DRAWING AMENDMENTS

Submitted herewith is a marked-up version of the amended drawings, in accordance with 37 C.F.R. §1.121(d). The amended drawings comprise sheets 1 and 4 labeled as Figures 1 and 4. Also submitted are replacement sheets.

FIG. 1
(PRIOR ART)

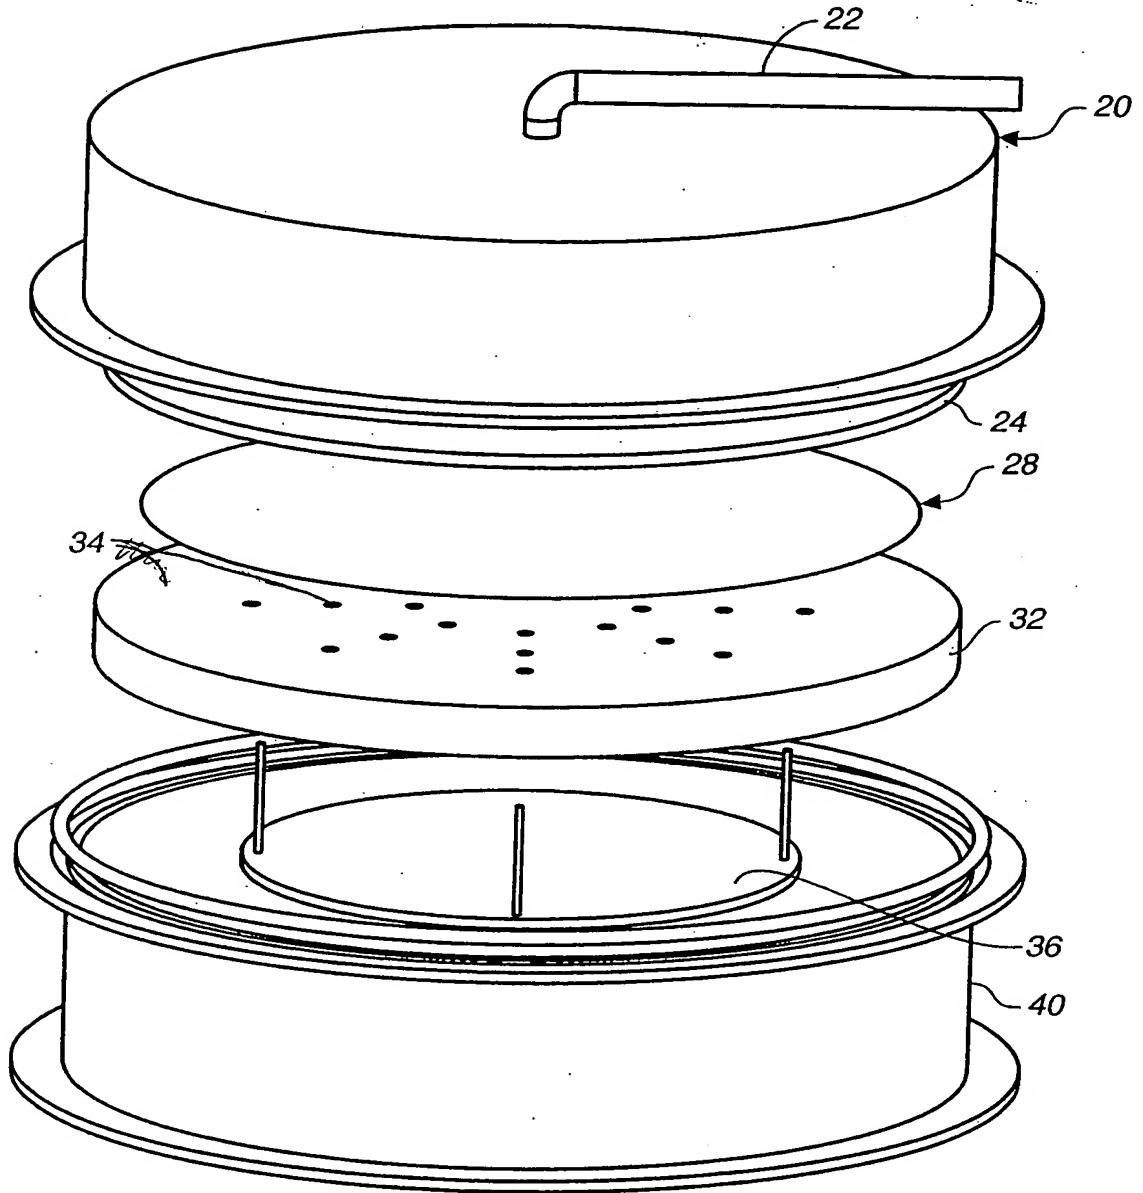
(2) The drawings were also objected to because reference numbers 132 and 133 of Figure 4 referred to the same part. An amended drawing is submitted showing reference number 133 referring to proximity pins 133 as shown in Figures 6 and 8. In addition, Figure 1 is amended so that proximity pins 34 are identified as shown in Figure 2.
